**WCAP-16996-P, "Realistic LOCA Evaluation Methodology Applied to the Full Spectrum of Break Sizes
(FULL SPECTRUM LOCA Methodology)"
Request for Additional Information – (Non-Proprietary)
Set 8 RAIs 127, 132-135 and 137-139**

January 2014

Westinghouse Electric Company LLC
1000 Westinghouse Drive
Cranberry Township, PA 16066

Figure 139-1: Noding Diagram for the 3D (Vessel) Parallel Channel Numerical Problems

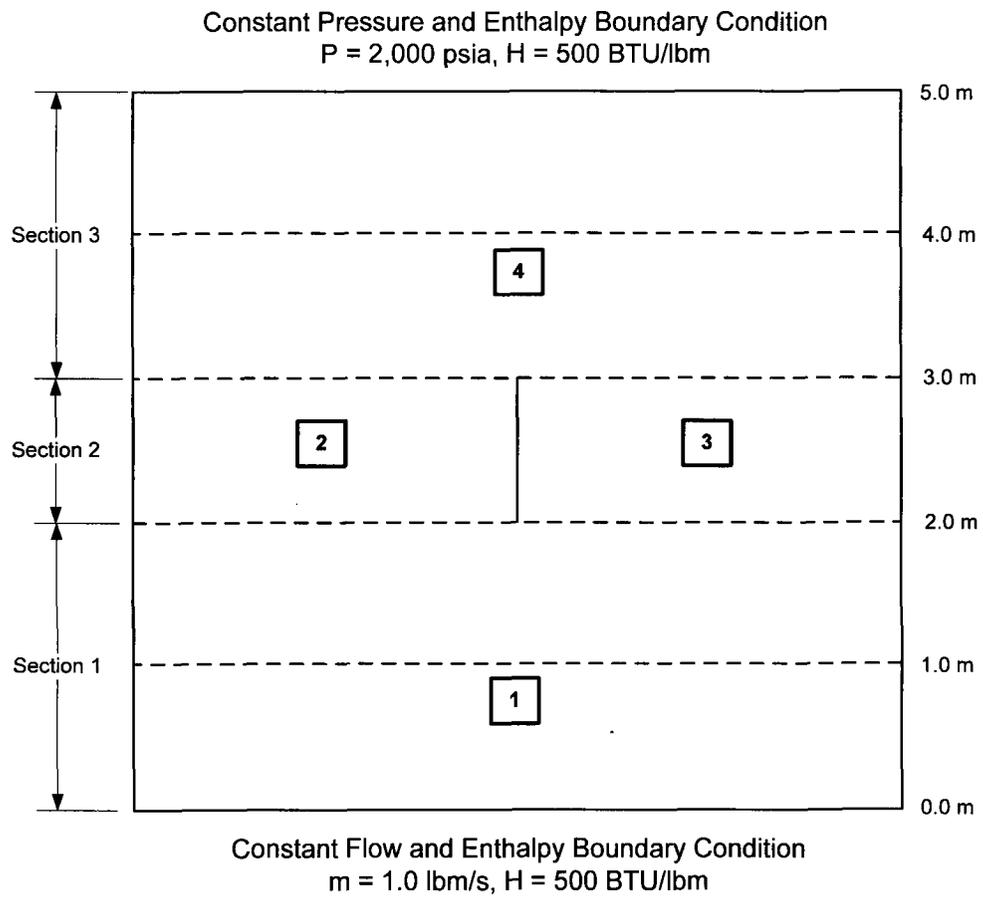
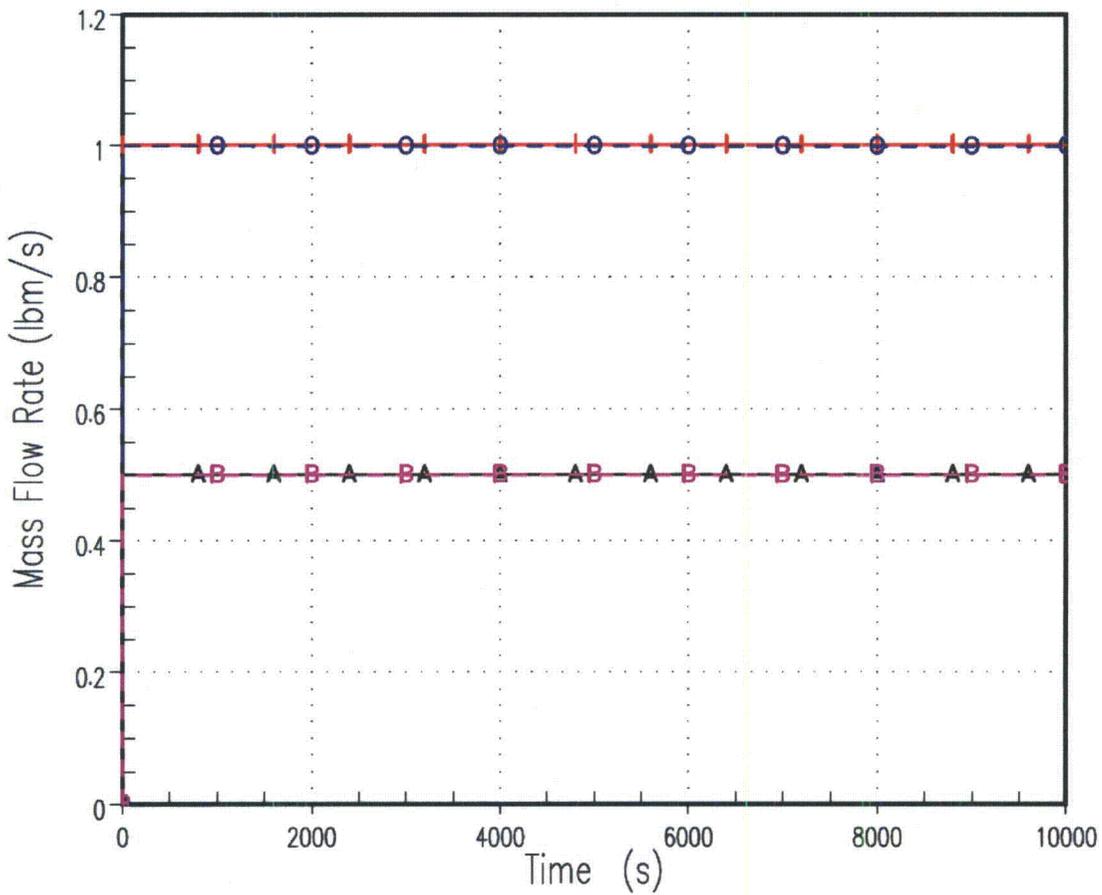
Please show that WCOBRA/TRAC-TF2 does not predict anomalous behaviors as described above for other codes when using three- and one-dimensional components. As part of the response, present predictions for an illustrative parallel pipe flow problem as implemented in the RELAP5 dual pipe flow input model presented below.

The noding diagram for the vessel parallel channel problems is presented in Figure 139-1 (dummy 1D components required to execute the code were omitted from the diagram). Four channels were used to model the problem. Vessel Sections 1 and 3, which represent the inlet and outlet of the test section, are both modeled with a single channel. Vessel Section 2, which is in between the inlet and outlet regions, is modeled with two identical channels. No loss coefficients were specified for any of the channels at any elevation.

For the first problem, the boundary conditions were specified as shown in Figure 139-1. A constant flow and enthalpy boundary condition was specified at the bottom of the vessel component, with a mass flow rate of 1 lbm/s and an enthalpy of 500 BTU/lbm. A constant pressure and enthalpy boundary condition was specified at the top of the vessel, with a pressure of 2,000 psia and an enthalpy of 500 BTU/lbm. These boundary conditions cause the flow path to be from the bottom of the vessel to the top of the vessel. For the second problem, the boundary conditions were switched such that the flow was from the top of the vessel to the bottom.
